ENGINEER'S DAILY REPORT

04-SF-80-13.2/13.9
Contract No. 04-0120F4
{SAS Superstructure}

- **Proposed Recommended Change on grounding issues in the contract.**
  Subject: Grounding issues.
  - Submitted a recommendation to correct conflicts, provide proper protection, update to changes to other contract changes that affect the grounding system in the SAS contract.
  - See attachment.

Attached Contract Plans with Comments : Grounding Issues - Comments by Michael Travis 12_07_2007.pdf

DETAILS
SAS SUPERSTRUCTURE GIRDER WESTBOUND GROUNDING PLAN
SCALE 1:2000

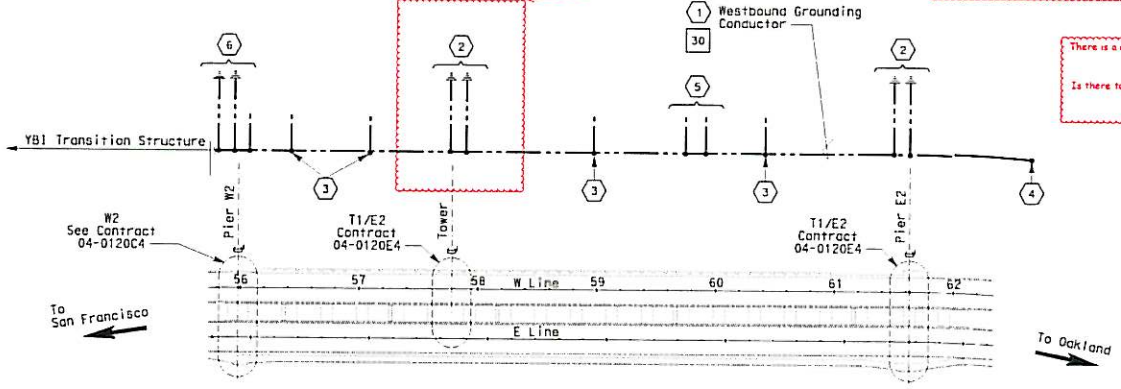
The contract plans calls for the grounding connection to the westbound ground conductor. This needs to be installed

The plans indicate that the ground conductor to be bare copper and run in the marine environment outside the structure.
The conductor outside the structure needs to be protected.

There is a conflict in the plans and there needs to be a clearification.

Is there to be two seperate runs from the tower footing or one?
See sheet

DETAILS
SAS SUPERSTRUCTURE GIRDER EASTBOUND GROUNDING PLAN
SCALE 1:2000

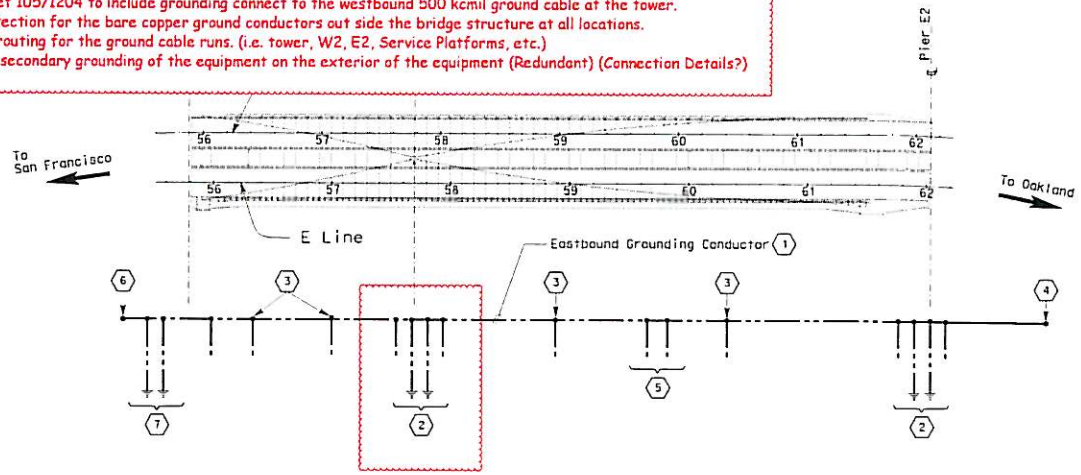
There is a conflict in the plans and there needs to be a clarification.

Is there to be two separate runs from the tower footing or one?
See sheet
